## **Compatibility bands – ECE R13**

### **(Proposal from the Danish delegation)**

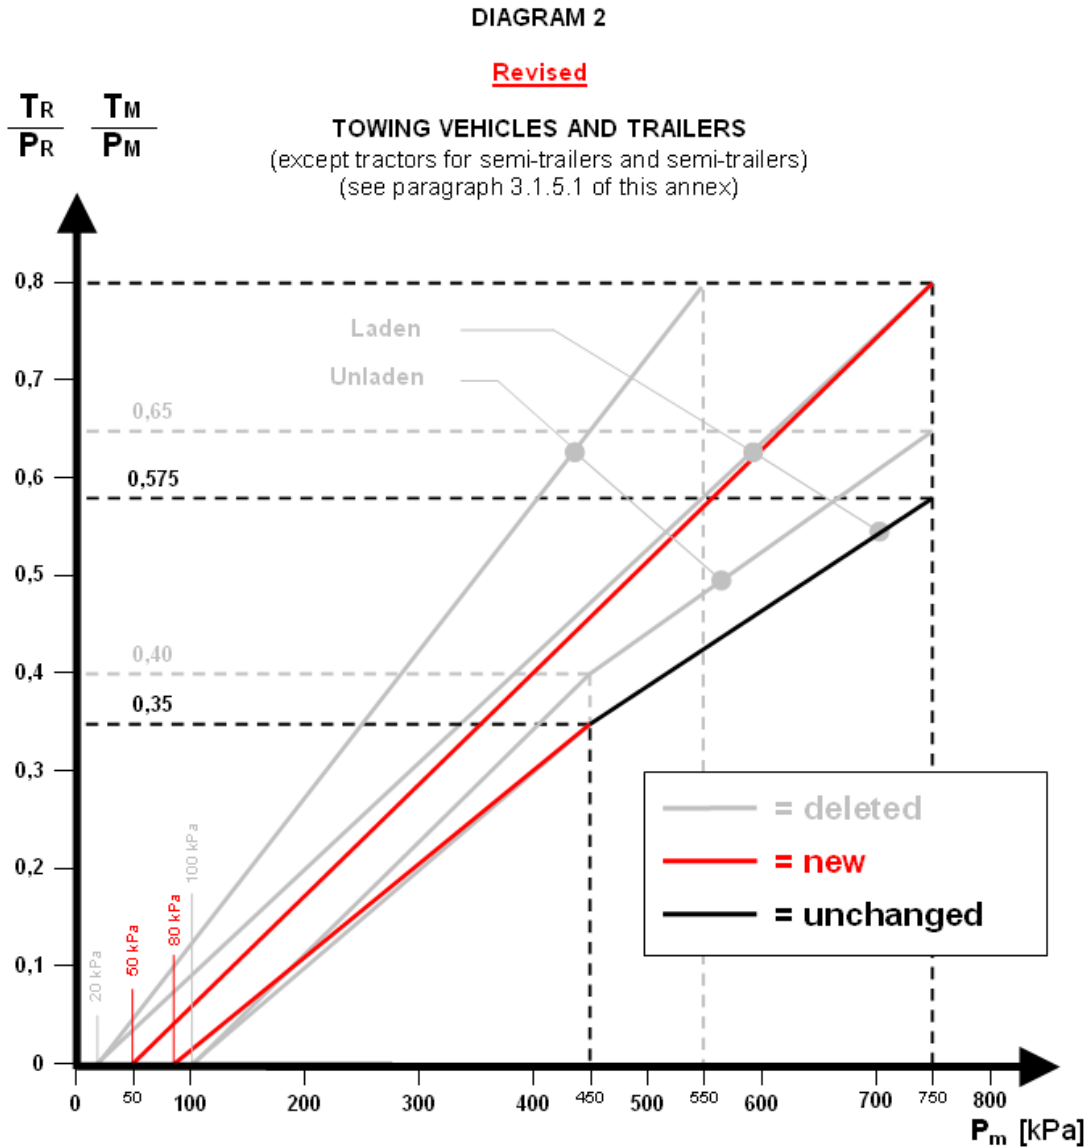
Brake compatibility between truck/tractor and trailer is enhanced by narrowing the limits for control line pressure versus brake rate in the area below 200kPa where most common brake events occur. The aim is to reduce the occurrence of too frequent exchange and disposal of not worn down brake pads due to sleeping and glazed brake linings thereby ensuring the presence of adequate brake performance throughout brake lining life.

To ensure compatibility not only in the full laden condition the compatibility bands should cover all load conditions in the area below 200kPa control line pressure.

Annex 10, diagrams 2, 3 and 4A, amend to read:

DIAGRAM 3

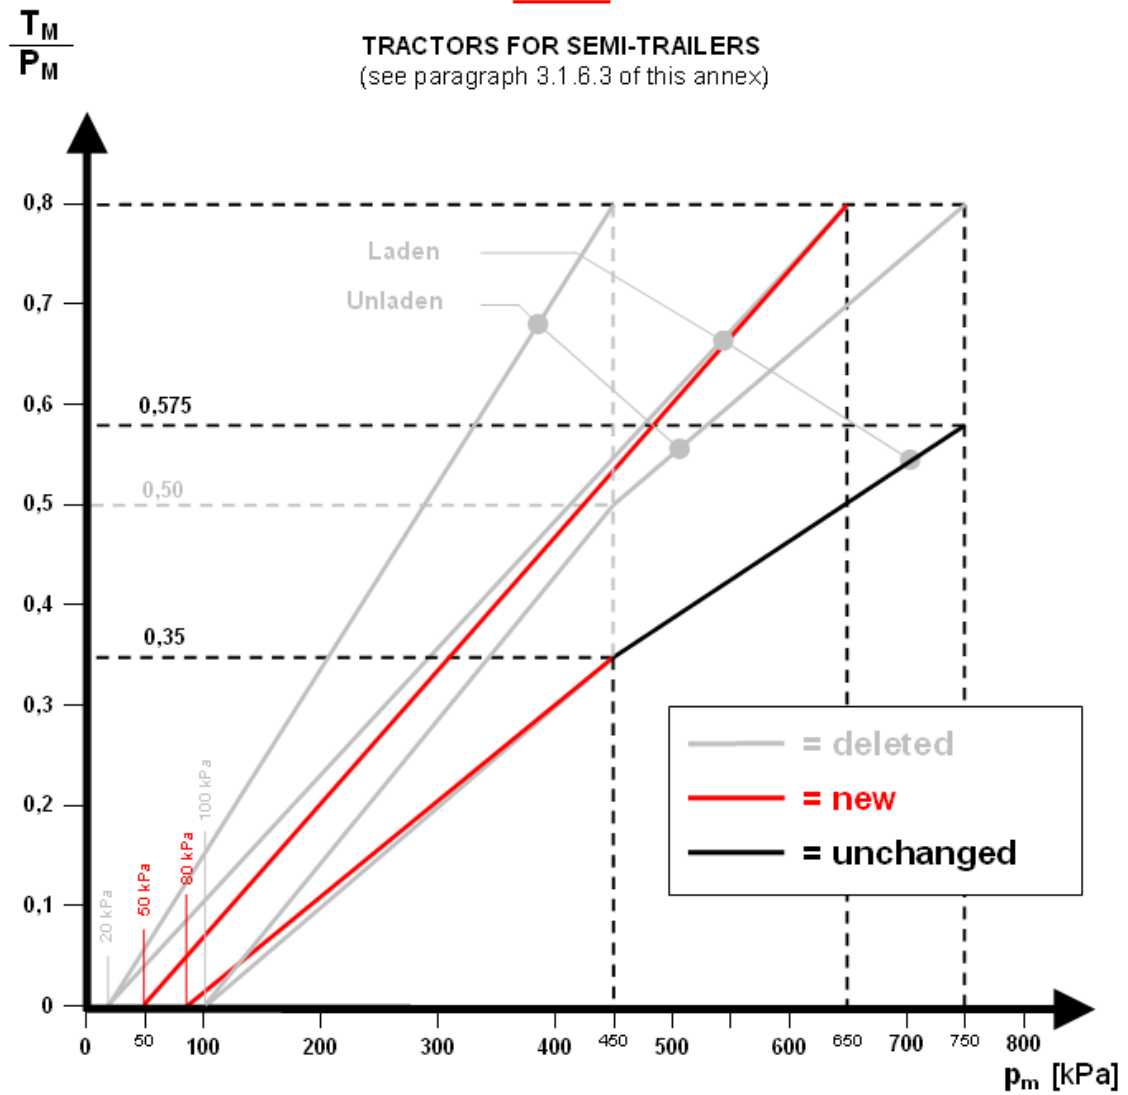
Revised

DIAGRAM 4

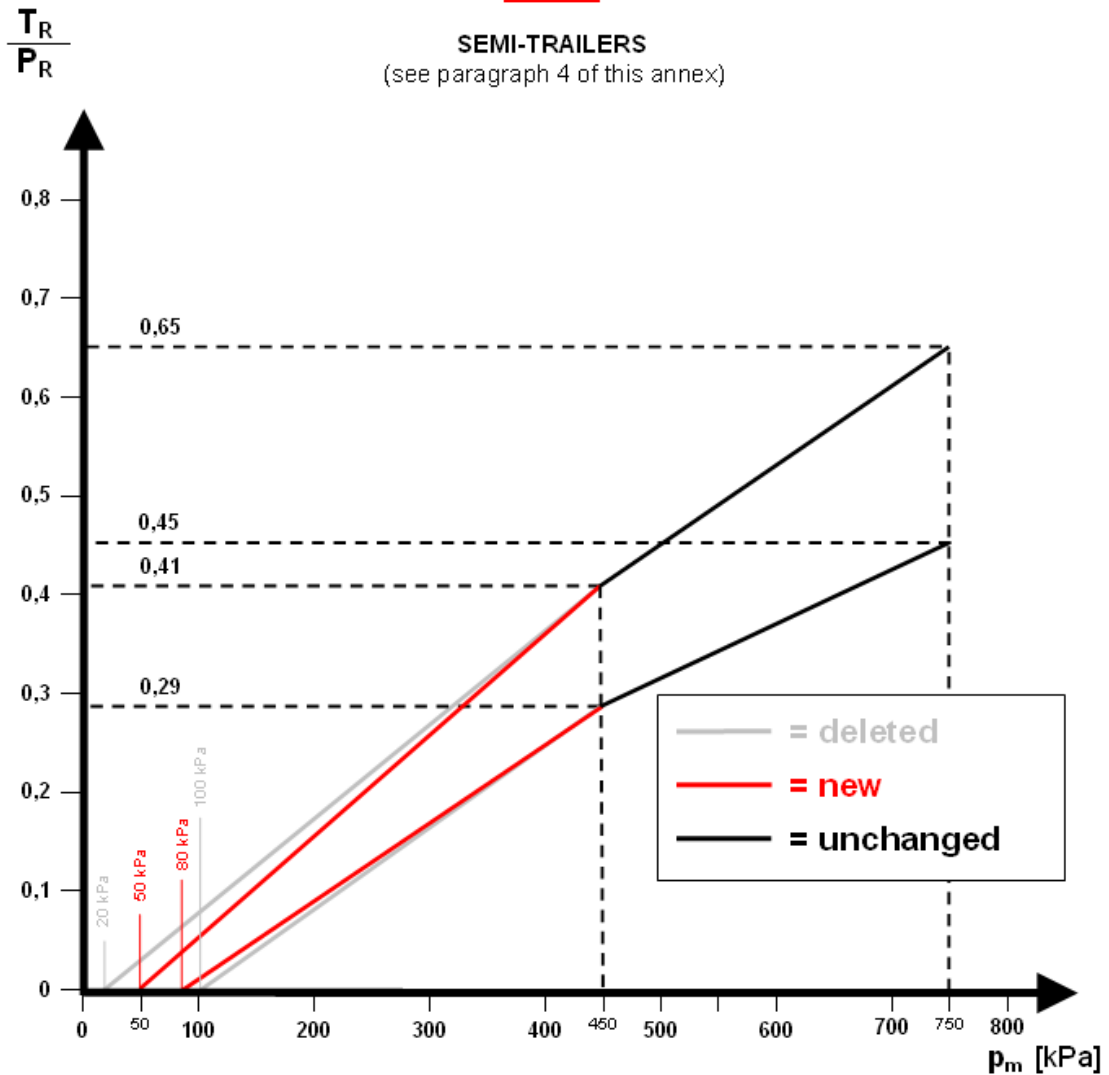
Revised
